SUBDIVISION REPORT - CONCEPT/SPECIAL USE

▶ **FILE #:** 2-SB-23-C **AGENDA ITEM #:** 17
2-C-23-SU **AGENDA DATE:** 4/13/2023

▶ **SUBDIVISION:** BUFFAT MILL ESTATES

▶ **PROPOSED USE:** Residential subdivision for duplexes

LAYOUT AND PAVING PLAN

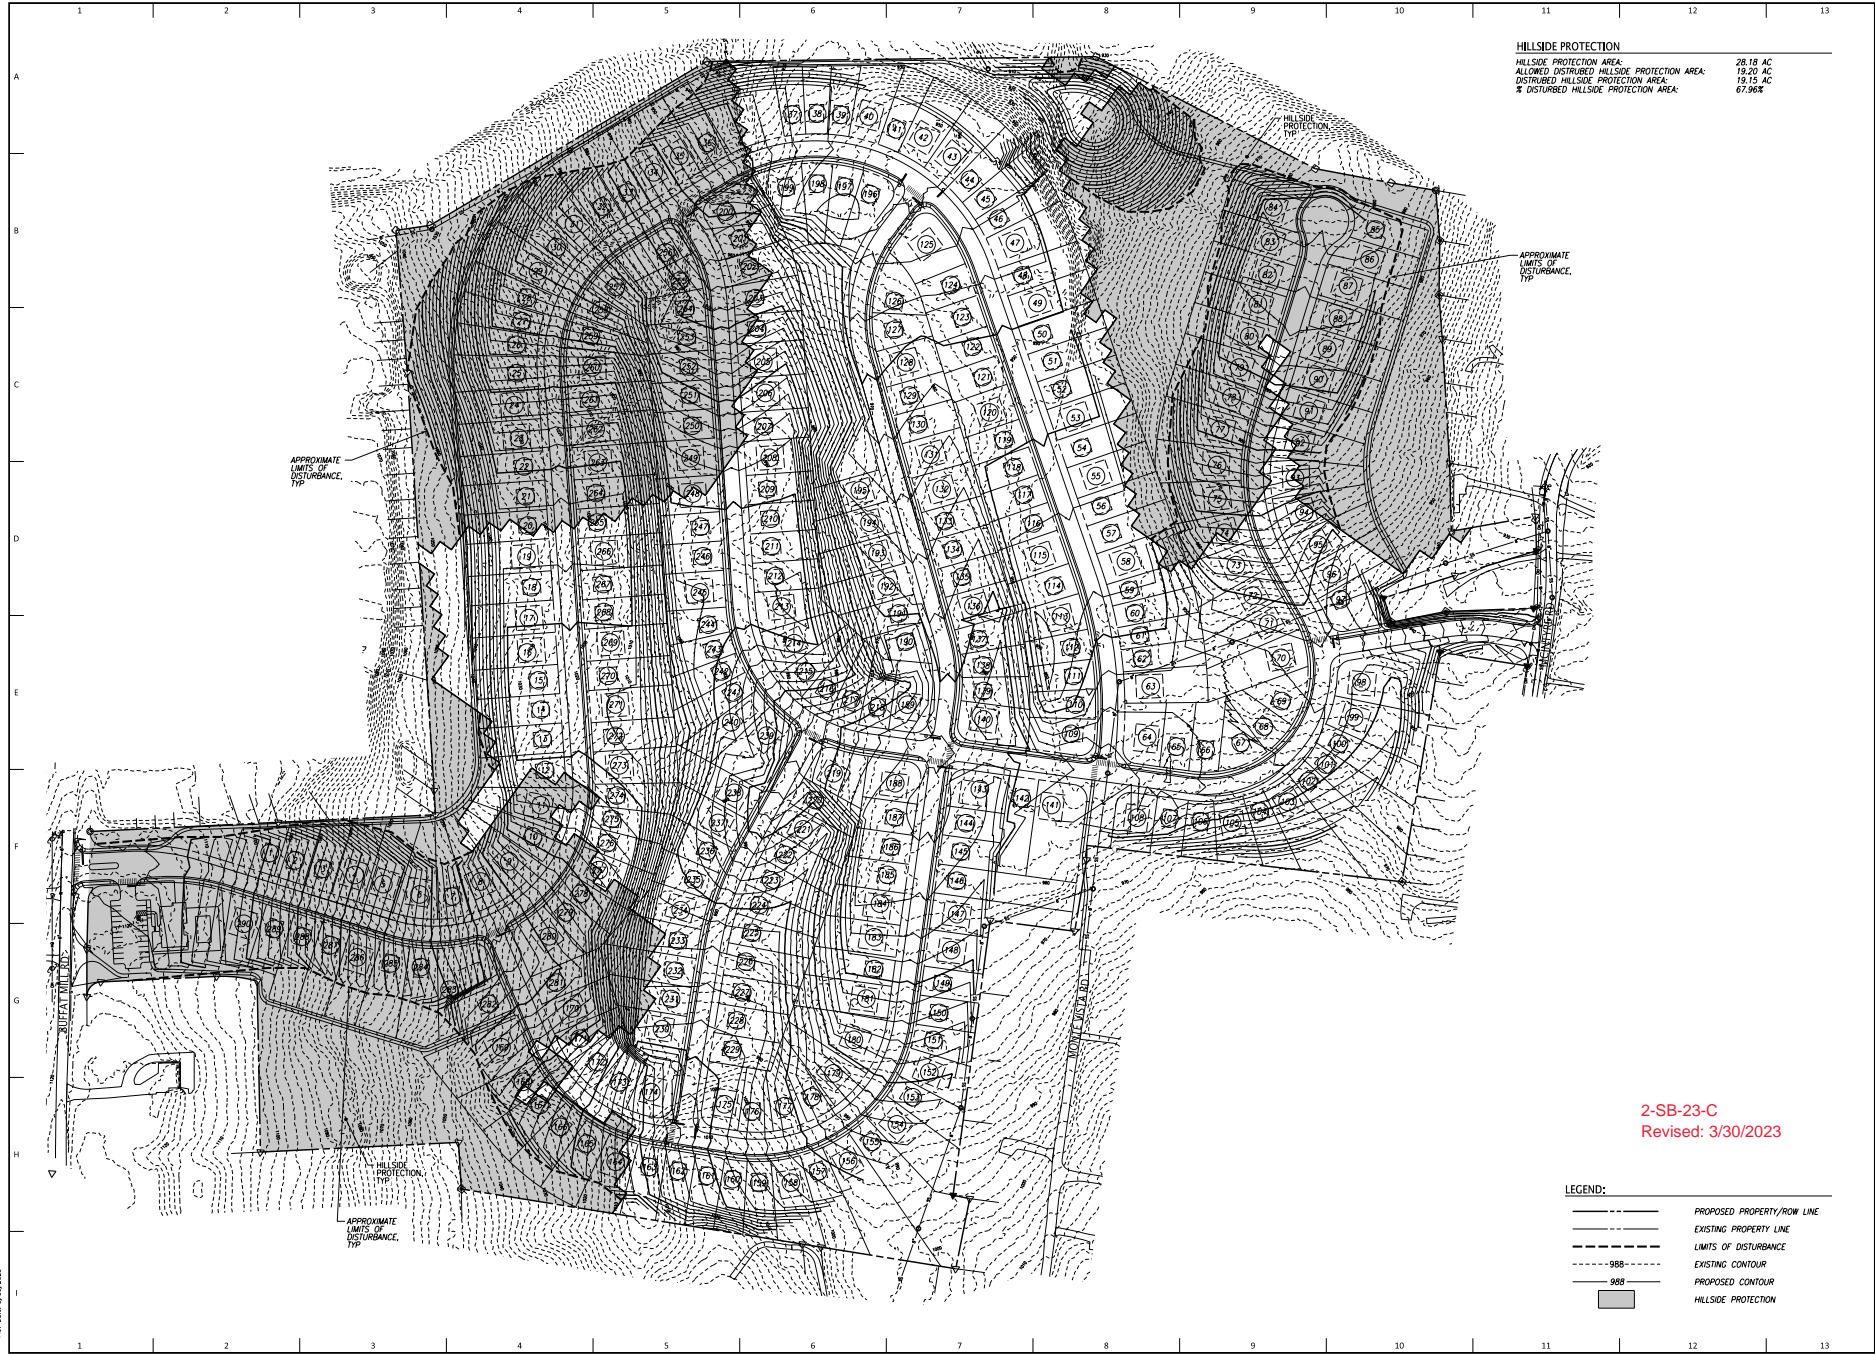
▶ **SUBDIVISION VARIANCES REQUIRED:** **VARIANCES**
1. Reduce the minimum intersection separation from 300 ft to 190 ft between the centerlines of Road 'A' and Locarno Drive.

7. Provide a right-of-way connection to the eastern right-of-way terminus of Monte Vista Rd from the southwestern intersection of Road 'A' and Road 'B'.

8. Provide a paved sidewalk from the southwestern intersection of Road 'A' and Road 'B' to the paved terminus of Monte Vista Rd. The sidewalk design shall meet the requirements of the Knoxville Department of Engineering during the design plan phase.

The proposed Road 'A' intersection at Buffat Mill Rd requires an intersection separation variance from 300 ft to 190 ft to Locarno Dr. There is limited opportunity to shift the access point further away from Locarno Dr. The reduced intersection separation is less of a safety concern because the intersections are on the same side of the street and will not create conflicting turn movements on Buffat Mill Rd.

- ▶ **Approve the requested variance and alternative design standard based on the justification provided by the applicant and recommendations of the City of Knoxville Department of Engineering.**

The City of Knoxville recommends consideration of these variances.

PRELIMINARY GRADING PLAN

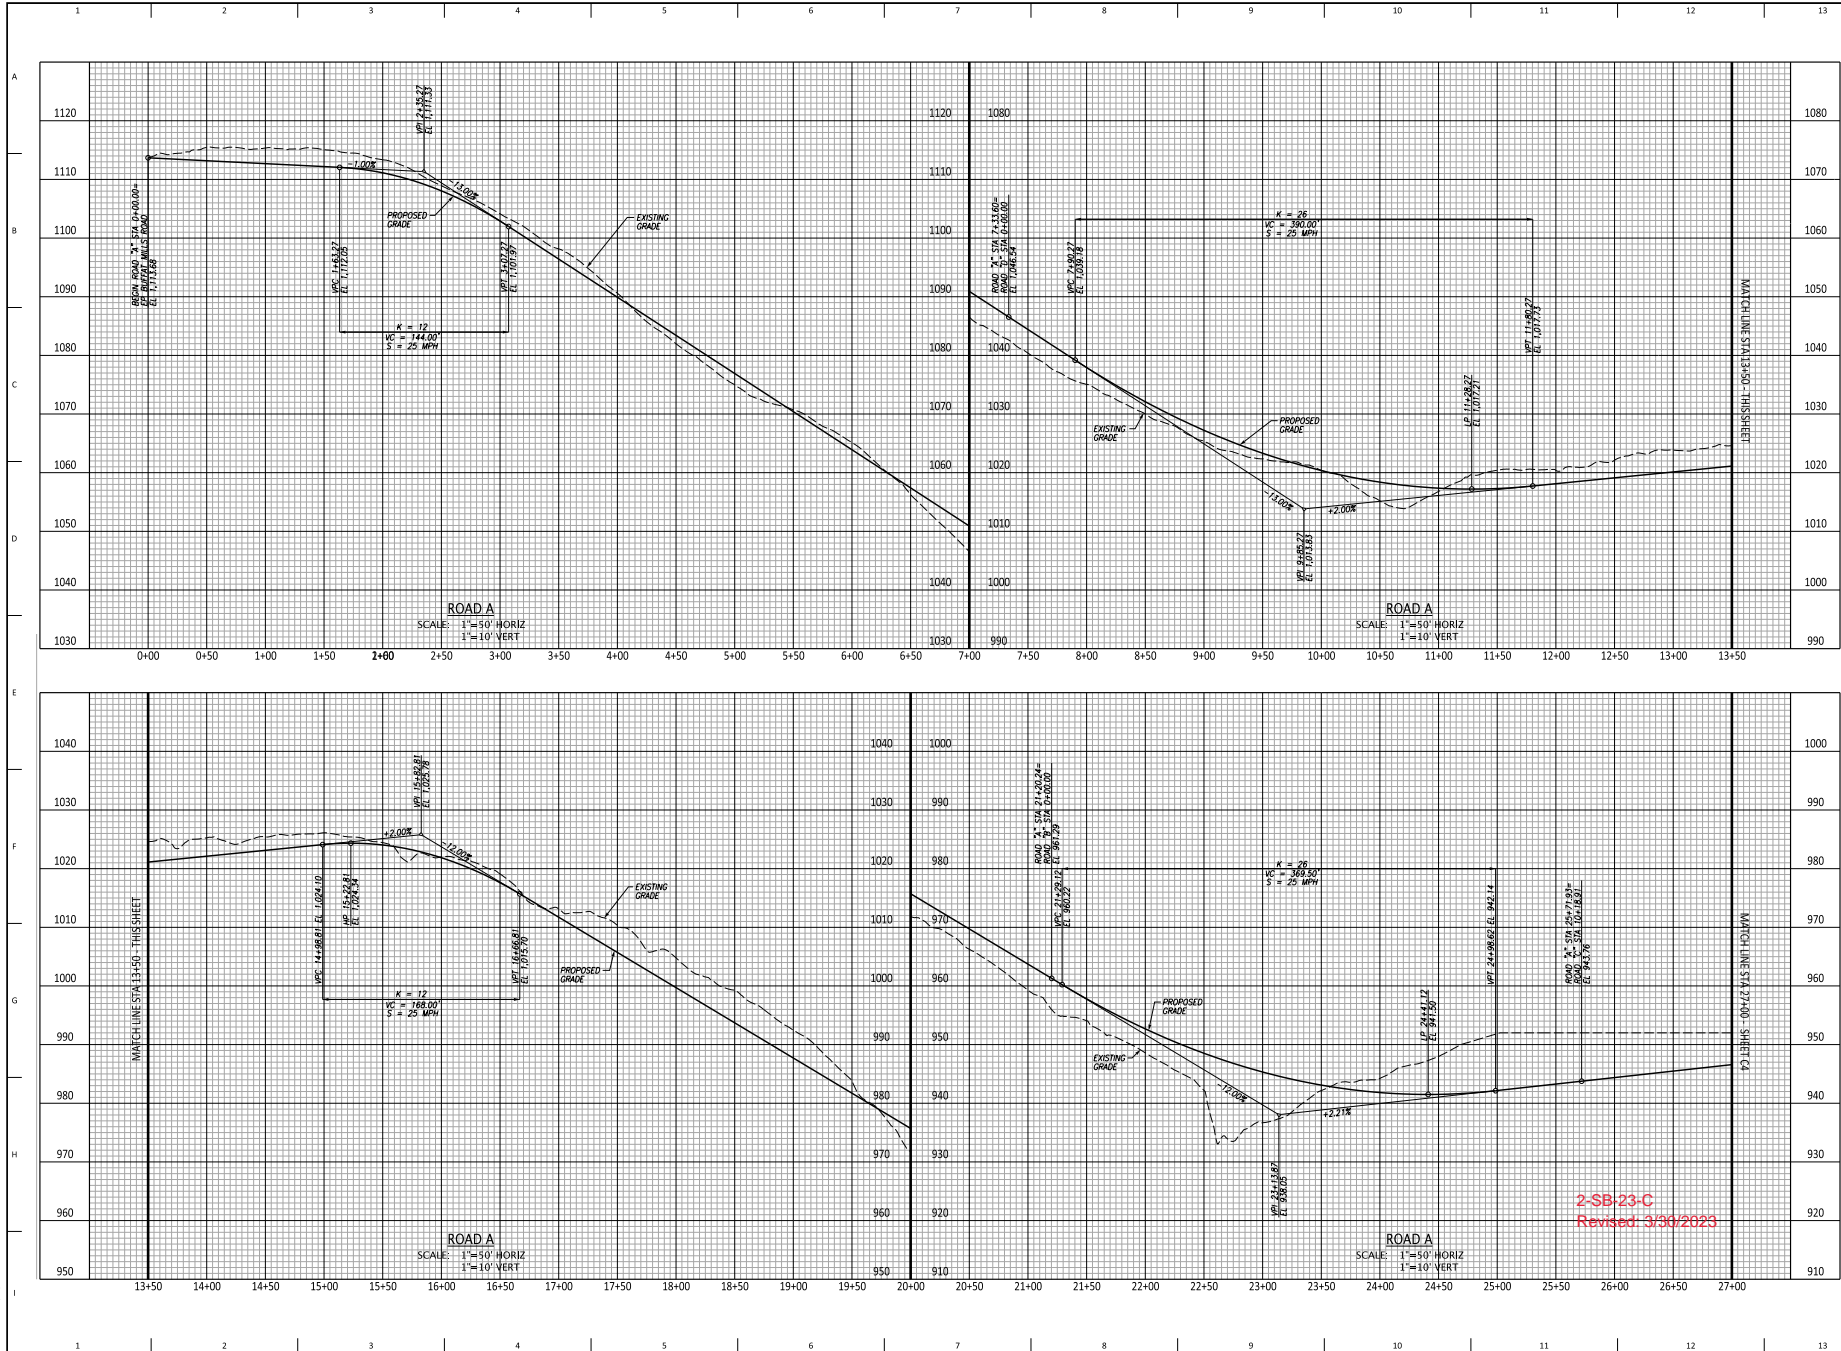
5. Provide sight distance easements on the final plat as required by the Knoxville Department of Engineering during the design plan phase.
6. Confirm that the land disturbance complies with the HP (Hillside Protection Overlay) zone district during the design plan phase.

Approximately 28 acres of the site are in the HP (Hillside Protection Overlay) zone. A maximum of 19.13 acres within the HP overlay can be disturbed. The applicant proposes to disturb 19.15 acres. Conformance with the disturbance limitations must be confirmed during the design plan phase.
